8496B-02

Modification Recommended Service Note

8496B – Manual Step Attenuator

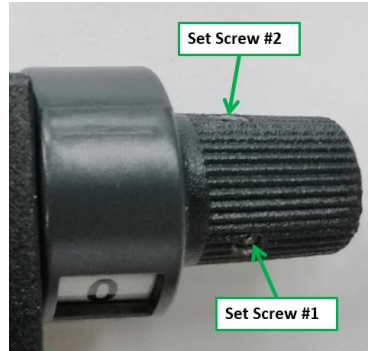
Situation:

The attenuation knob was not securely tightened to the internal shaft, causing it to turn further. This is due to an insufficient torque that was applied to tighten the set screw during assembly at the factory.

This issue can be fixed by re-tightening the screws on the rotating knob.

- (1) Rotate the knob clockwise until it reaches the last attenuation step, which is at 0 dB.
- (2) Loosen the 2 set screws (0.05" Hex screw bit) on the knob slightly until the knob can freely move, and then align the knob so that the indicator label number "0" is located at center on dial cover window.

- (3) Tighten both set screws with a 0.05" Hex screw bit and 4.0in-lbs torque driver.

(4) After tightening both set screws, rotate knob counter-clockwise until it reaches the maximum attenuation (11/70/110dB). To ensure the attenuator functions properly, rotate the knob clockwise back to minimum attenuation (0dB), and repeat the movement for 10 cycles.
